**Chapter 102 Inspection Report No. 26-02 —
PAC210079A-4**

Re: Pennsylvania Digital 1 (PAX-1)
NPDES Permit Application No. PAC210079A-4
Middlesex Township, Cumberland County

CHAPTER 102 INSPECTION REPORT

Photo 2

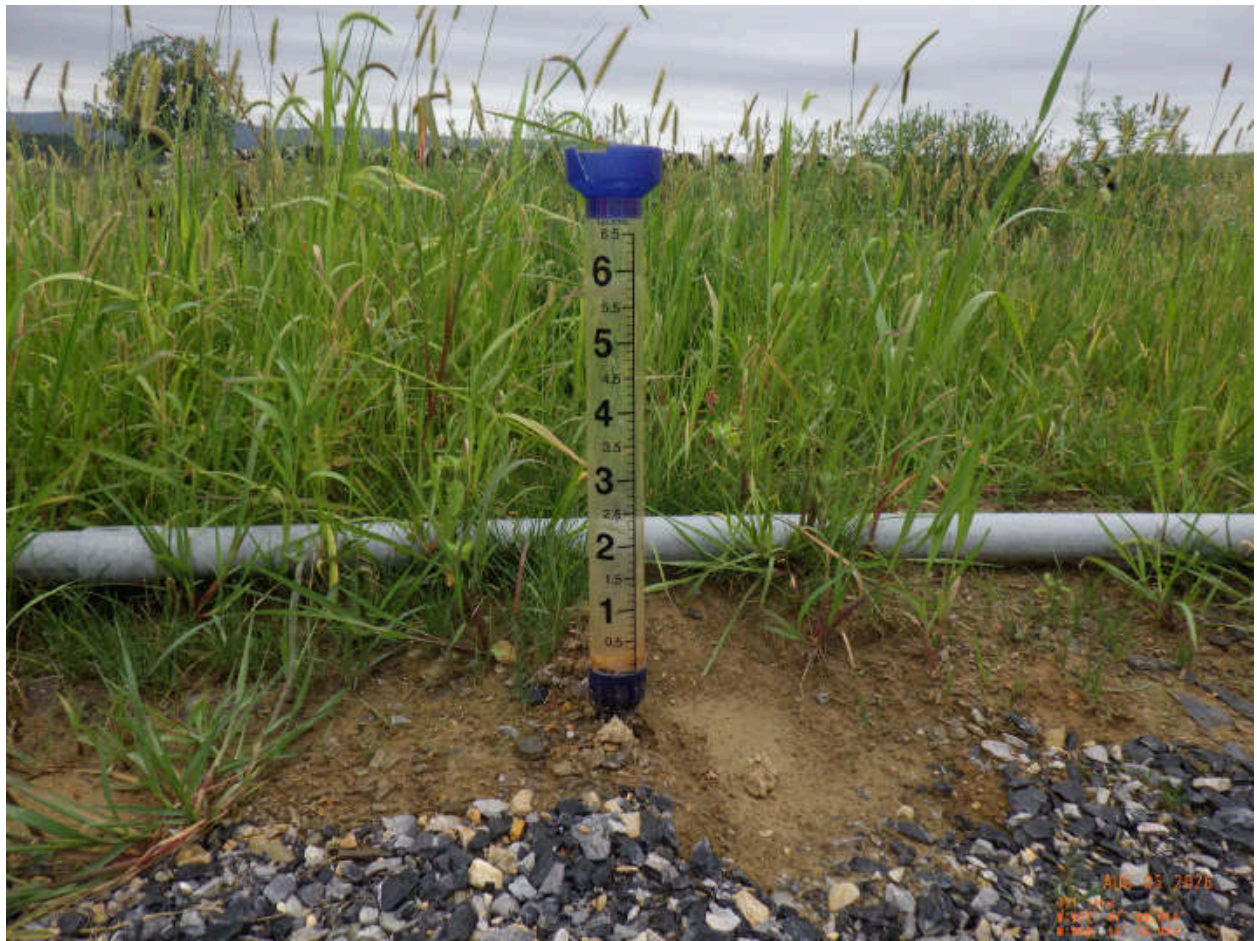
2. Active Street sweeping on Country Club Road was observed at the time of the inspection. Photo 1
 3. Existing PPL Laydown Sediment basin was full of stormwater but was actively being dewatered via trash pump and pumped water filter bag. The filter bag was situated on a well vegetated area and wrapped in a compost filter sock. Photos 2, 60-66.

- CCCD recommends pumping the water from the Existing PPL Laydown Sediment Basin within 96 hours following a runoff event. This water may be utilized to spray the site to minimize dust. Sediment Basins are to be empty between runoff events. Using the system referenced in observation 3 of this report is ok. - Ensure the site continues to be inspected weekly and after each measurable runoff event (>0.25 inches). - Ensure any area of the site that is idle for four (4) or more days, including stockpiles, is temporarily stabilized. - The observations noted within #6, 7, 8, 9, 10, 12, 13, 14 and 15 should be corrected as soon as possible. Once corrections have been made, the District requests Liberty to send photos of all repairs to the District.
